# PEER REVIEW COMMENTS ON THE MODEL VALIDATION REPORT

## Questions for the Model Validation Report

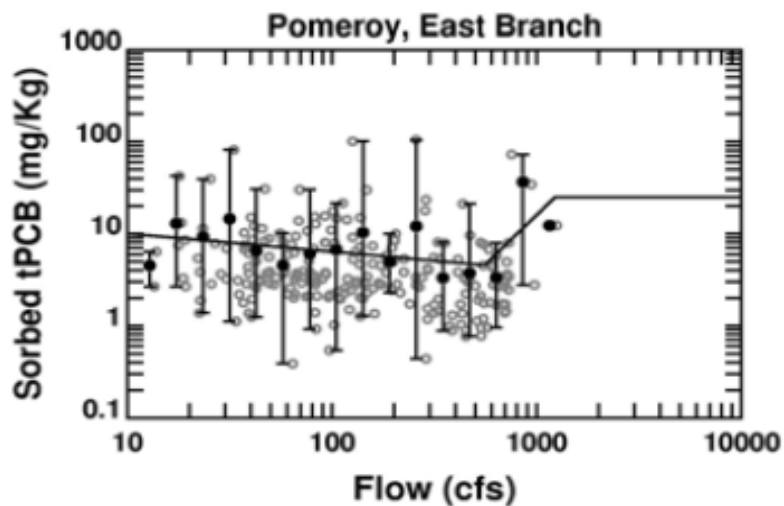
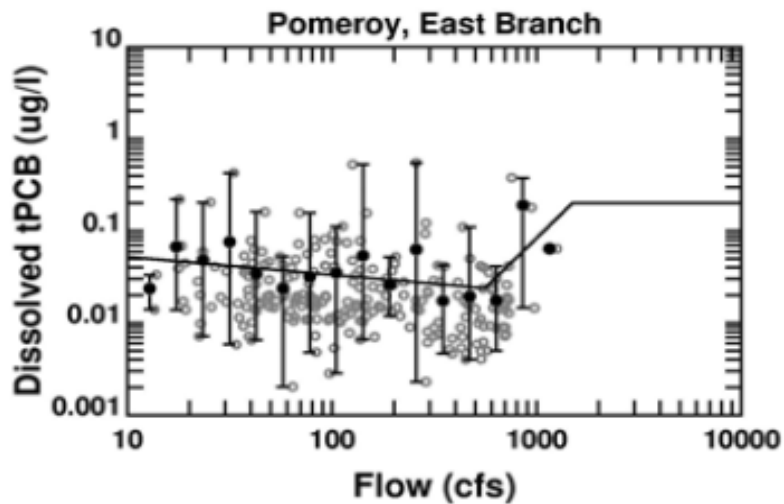
1. As a general observation, I would say that if one focuses on the actual data plotted in these graphs (the open circles), it appears that EPA’s regressions describe relatively little of the variability observed in PCB concentrations at the boundary condition. The regressions are especially tenuous at low and high flows. In fact, the regressions exceed all of the data in the lowest flow “bin”.

2. I cannot find the PCB concentration data collected at flow rates smaller than 24 cfs<sup>3</sup>. Therefore, I have no way to confirm the results shown in Figure 4.1-2 for the two lowest-flow “bins”. At least for the lowest “bin”, the regression line appears to be a poor fit. A noted above, it exceeds all of the measured data.

3. At high flows, the PCB concentrations are “capped” to prevent unrealistically high PCB concentrations during floods. The “cap” was specified as 25 mg/Kg for particulate PCBs, based

upon concentrations measured in sediments deposited on vegetation and banks. I think this value may be somewhat too high. My own calculation of the unbiased mean PCB concentration from the 13 sediment deposit samples is 20.5 mg/Kg, although I was measuring the data off of a graph. Please check this calculation. If 25 mg/Kg is indeed too high, it will bias the high-flow PCB boundary condition.

4. According to EPA, the detection limit was used as replacement values for censored PCB concentrations. While this has little impact on the distribution of total PCB concentrations, it does bias the particulate PCB concentrations that are calculated from total PCB measurements using the partitioning model. I didn't check, but I suspect that dissolved PCB concentrations may be biased as well. I think it is generally preferable to use one-half of the detection limit as replacement values for censored PCB concentrations.

5. Another thing I noticed when I reproduced EPA's partitioning calculation (which is used to estimate the dissolved and particulate PCB concentrations from the total PCB measurements), is that the dissolved PCB concentration estimates don't agree very well with the relatively few dissolved PCB concentrations measured at the boundary condition. This is shown below in Figure 2. If the partitioning model is being used to describe the boundary condition, shouldn't it fit the data?

6. Frankly, some of this data is mystifying. For example, 2 samples were collected on November 12, 1995. For both samples, the flow is reported to be over 1,100 cfs. In the first sample, [TSS] was 450 mg/L and total [PCB] was 0.2 ug/L. In the second sample, [TSS] was 17 mg/L and total [PCB] was 0.52 ug/L. Running these values through the partitioning model, one obtains particulate PCB concentrations of 0.44 and 23 mg/Kg. It is somewhat hard to believe that PCB concentrations on suspended solids could vary by a factor of 50 within one day.

**Figure 3**

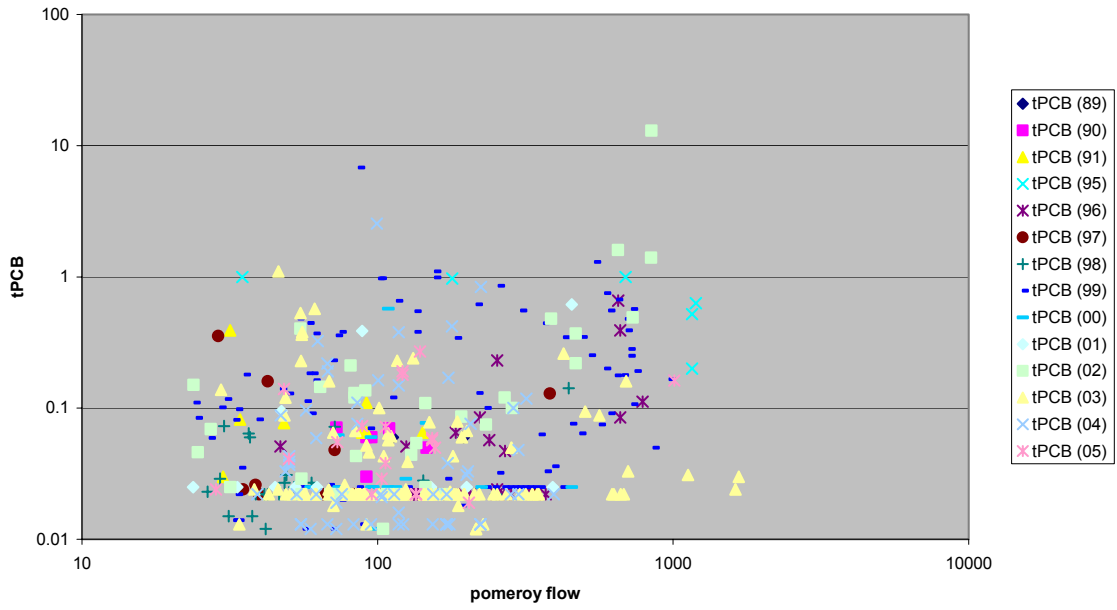
7. It is also curious to me that there has been no shift or evolution in PCB boundary concentrations over the past 16 years, and that seasonality is not evident in the data. If PCB boundary condition data for all years are plotted together, we see the familiar shotgun target (Figure 3). There appears to be some underlying behavior, however, within individual years of data. Figure 4 shows total PCB data for years (especially 2002) in which a positive relationship with flow is evident. Figure 5 shows total PCB data for years (2003 in particular) in which the flow relationship is generally negative. The highest total PCB concentrations in Figure 5 come from the warm (and presumably higher organic carbon<sup>4</sup>) months of July-September, while the lowest PCB concentrations at very high flow were sampled in October and November. While I am confident EPA has looked at this data in great detail, I think the patterns in the data hinted at here suggest some underlying behavior which could be exploited in the regression models used to describe the boundary condition. I believe this might, in turn, provide better PCB boundary condition estimates than the current approach in which all measurements are lumped into one sample.

Figure 6

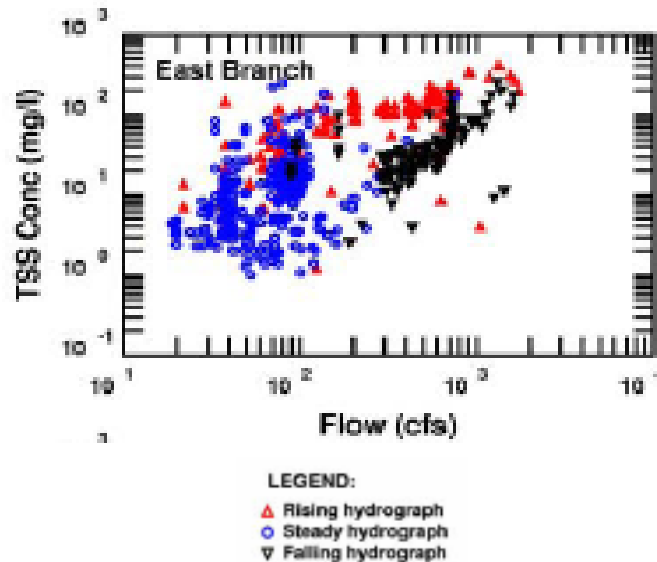
9. I also went back to look at the TSS boundary condition, which has not been changed from the Phase 1 calibration. Figure 6 is a reproduction of the plot displaying the East Branch TSS data as a function of flow (from: Volume 3—Appendix B Hydrodynamic and Sediment/PCB Fate and Transport Model Calibration, Attachment B.3 TSS and PCB Flux Analysis). The TSS data were partitioned according to 3 phases of the hydrograph – rising, steady and falling. TSS data are well-behaved during rising and falling hydrographs, but not at steady (and predominantly low) flow. This makes me wonder again about seasonal factors, intermittent upstream disturbances, or possibly sampling artifacts. It is hard to imagine TSS concentrations varying between 1 and 100 mg/L at base flow.
